UNITED STATES PATENT AND TRADEMARK OFFICE

APPLICATION NO.	FILING DATE	FIRST NAMED INVENTOR	ATTORNEY DOCKET NO.	CONFIRMATION NO.
10/707,337	12/05/2003	Staffan Wendeberg	00173.0049.PCUS00	1336

Office Action Summary

This is a first office action on the merits of patent application S. N. 10/707,337.

Fig. 22

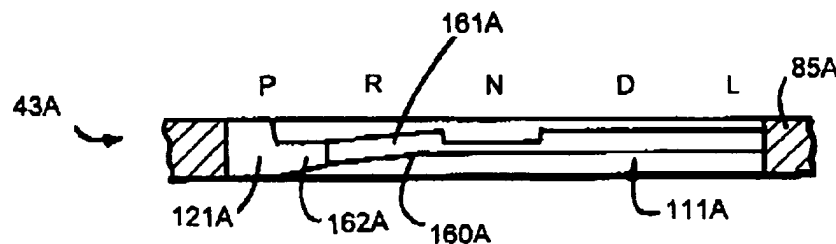
Claims 1 and 5 are rejected under 35 U.S.C. 102(b) as being anticipated by Beattie et al. ('196).

Beattie et al. discloses a gearshift unit comprising a gearshift housing (31), a lever (34), a main pivot axis (Y), an active position range (111A) and a neutral lock (133A), and a pivot pin (113).
